2-22 William Street, Granville
Urban Design Study

P18-019
26.02.2019

Figure 4: Site 1 Typical Floor Plan Compliance Comments - Level 3 (Fourth Storey) shown

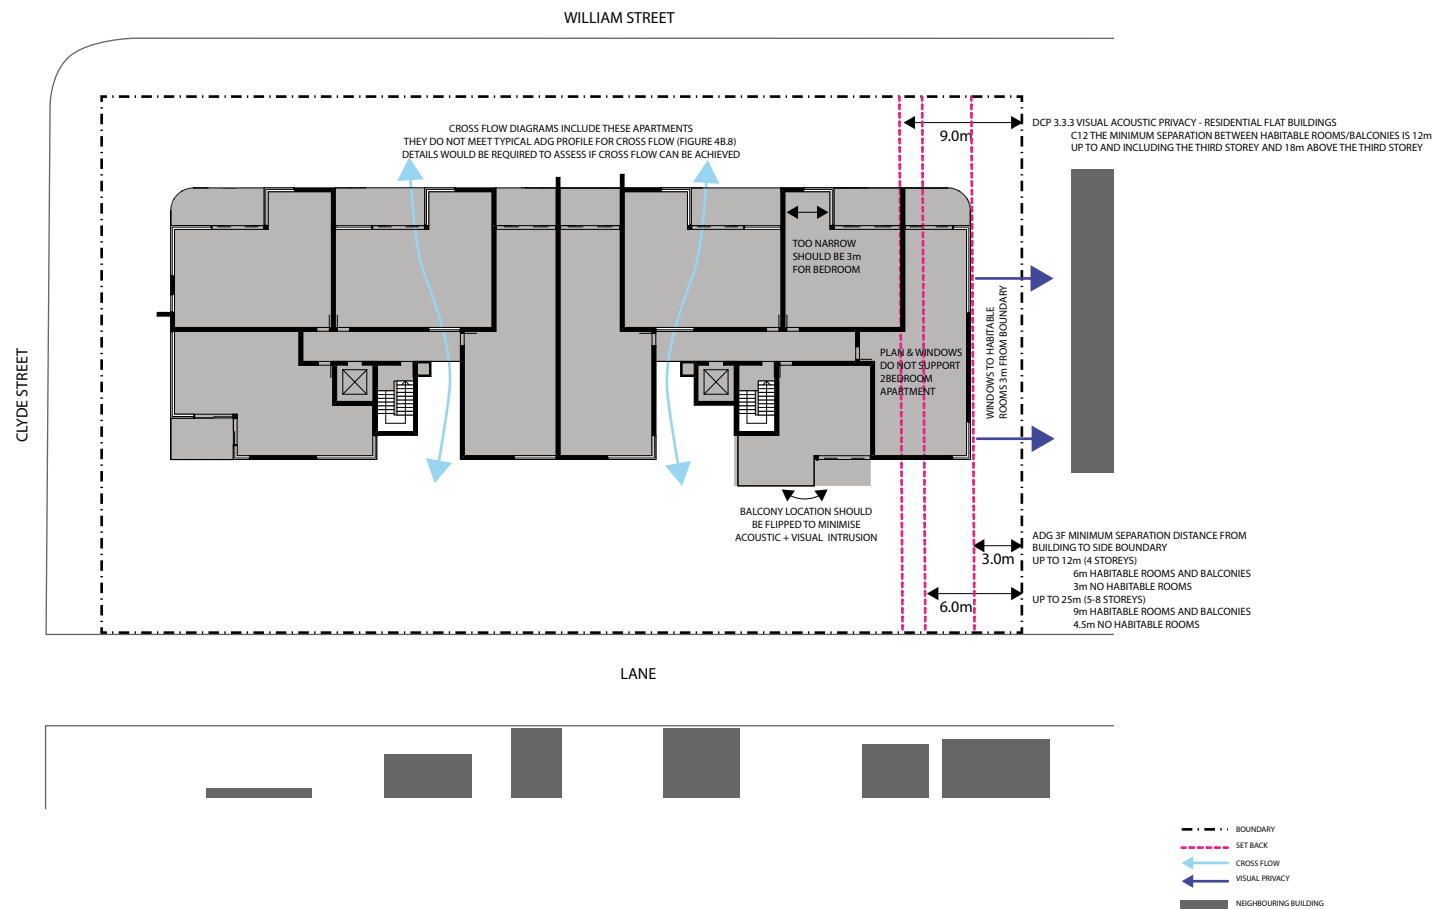
The diagram below illustrates compliance issues with the built form provided for Site 1 in the current planning proposal. These include:

- Overall height including lift overruns is 20m.
- 45 degree upper level setback not met.
- Inadequate deep soil zone for tree planting as carpark extends under communal open space.
- Rear setback is non compliant with DCP.
- Some apartments do not meet cross flow ventilation requirements.
- Does not meet ADG separation requirements on eastern boundary.
- Room dimensions do not meet ADG requirements.
- Building does not step with topography.

Figure 10: Site 1 Planning Proposal Envelope

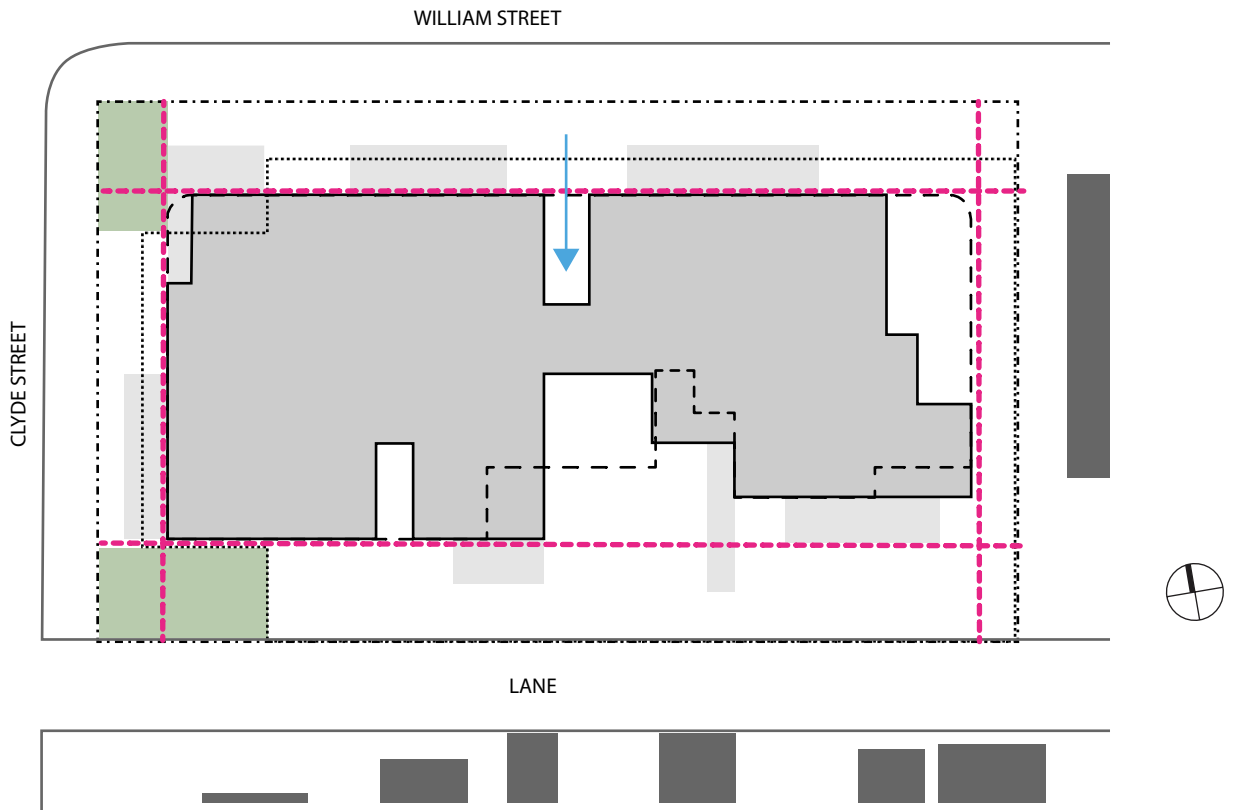
Deep Soil Zone	107m ²	4.9% *
Communal Open Space	560m ²	26% * (rooftop)

* Does not meet DCP/ADG requirement

Figure 11: Site 1 ADG & DCP Compliant Envelope

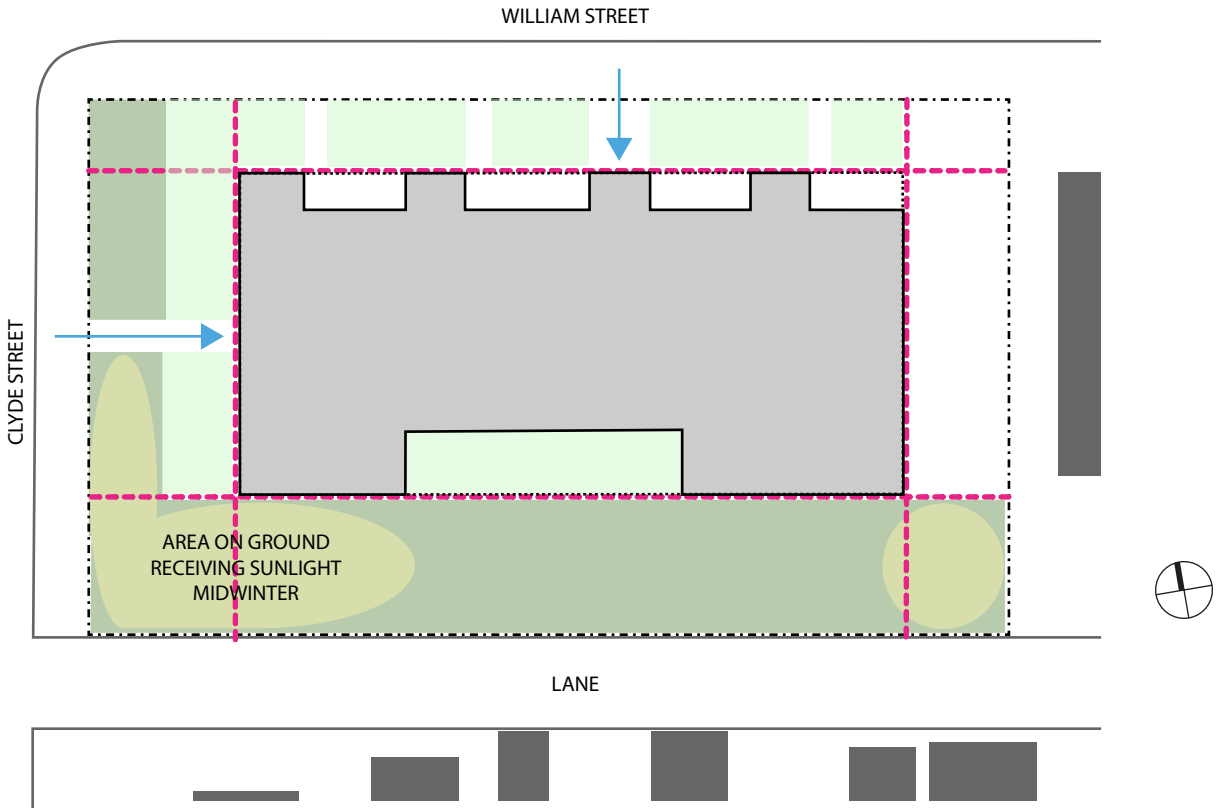
Deep Soil Zone	700m ²	32.1% *
Communal Open Space	550m ²	25% *

* Meets DCP/ADG requirement

Figure 12: Site 1 William Street Elevation: Planning Proposal

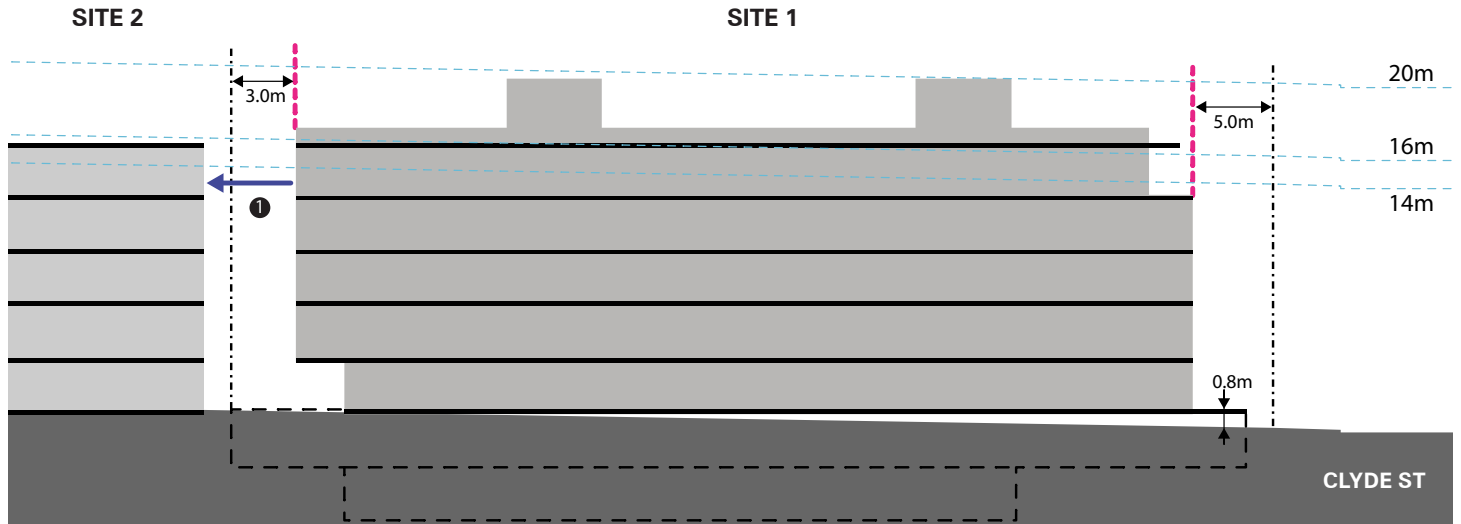
- 1 ADG 3F VISUAL PRIVACY: FOR SIDE WALLS
NO WINDOWS TO HABITABLE ROOMS

Figure 13: Site 1 William Street Elevation: Option: ADG + DCP Compliant

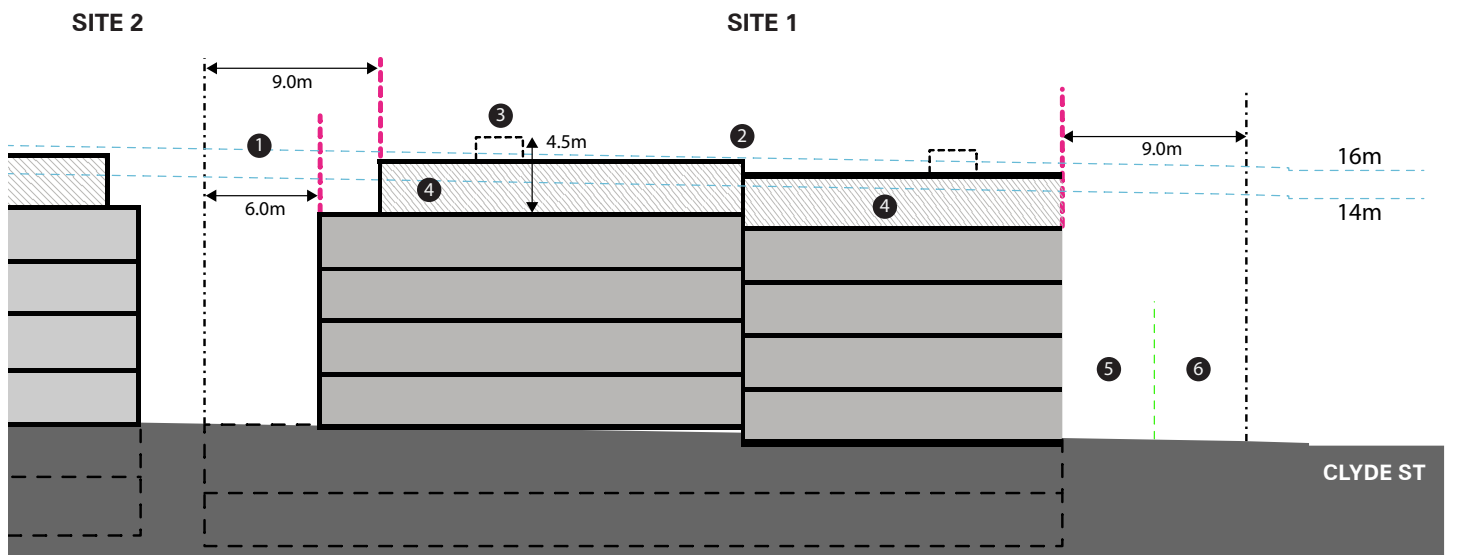
- 1 ADG 3F - VISUAL PRIVACY:
 - FIRST 4 STOREYS 6 METRES FOR HABITABLE ROOMS
 - FIFTH STOREY AND ABOVE 9METRES SEPARATION FOR HABITABLE ROOMS
- 2 ADG 2C - STEPPED BUILDING FORM TO FOLLOW TOPOGRAPHY AND HEIGHT CONTROL PLANES
- 3 TYPICAL LIFT OVERRUN 4.5M ABOVE LAST SERVICED FLOOR
- 4 LEVEL 5 OPTIONS:
 - OPTION 1: LIFT WITHOUT LIFT OVERRUN
 - OPTION 2: LIFT NOT SERVICING LEVEL 5 AND LEVEL 4-5 TO BE TWO STOREY UNITS
- 5 GROUND FLOOR PRIVATE GARDEN
- 6 COMMON SEMI PUBLIC OPEN LANDSCAPE AREA

Figure 16: Shadow Study at mid winter without development

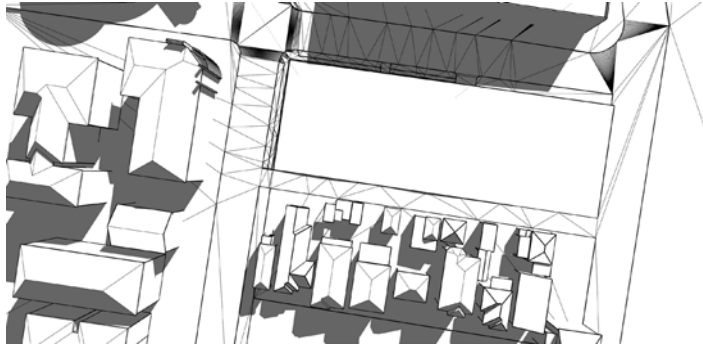
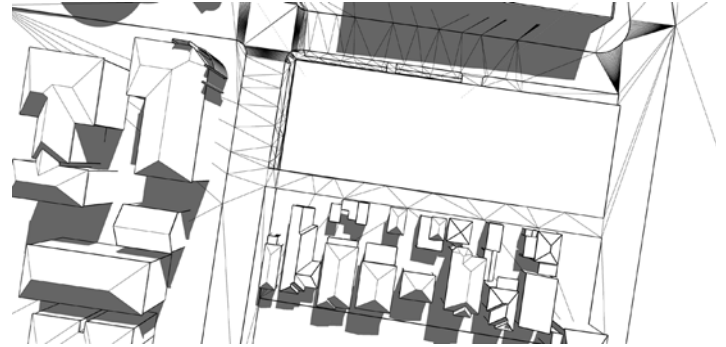
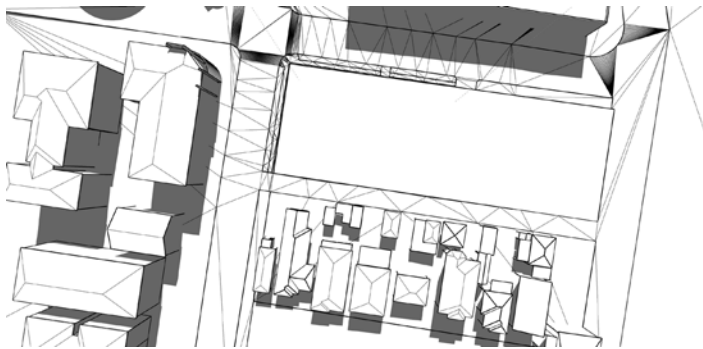
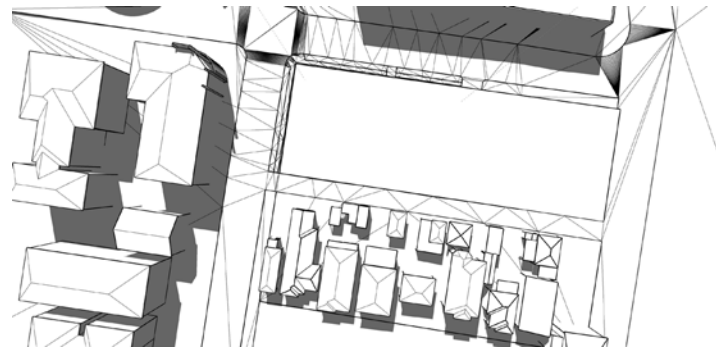
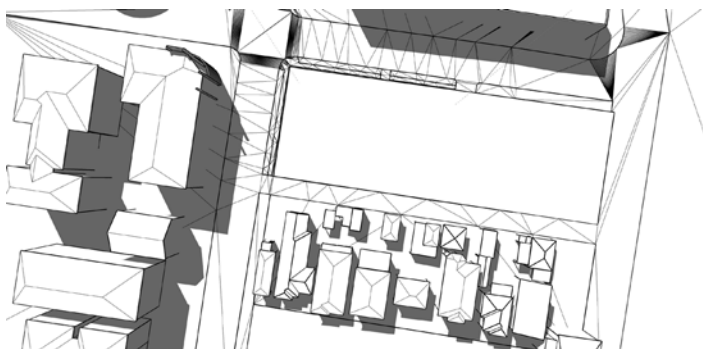
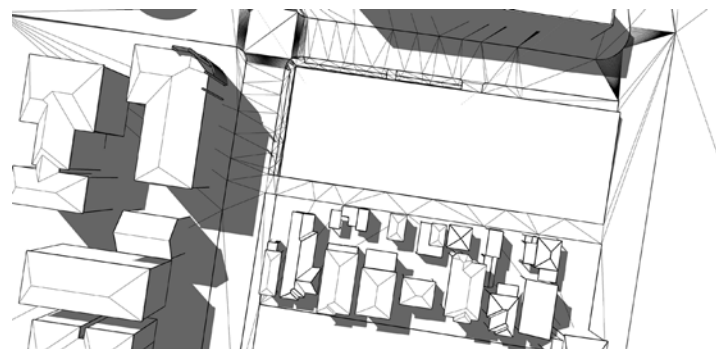
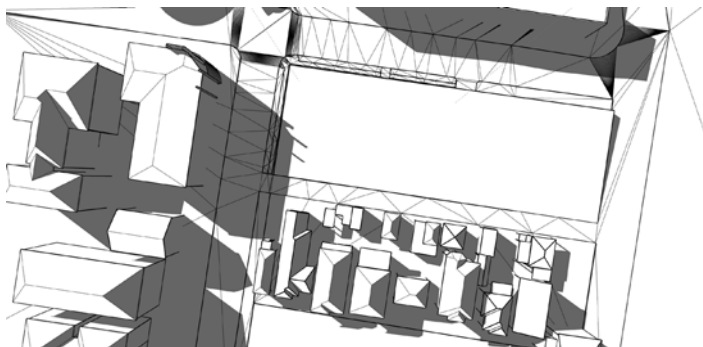
Figure 16 shows that properties at No.s 5,9,11,13 and 15 First Street have existing rear buildings that already significantly overshadow their own rear open spaces. Looking at the existing shadow diagrams for the 21 June, for No.s 5, 9, 11, 13 and 15 it is arguable whether they currently achieve the DCP requirement.
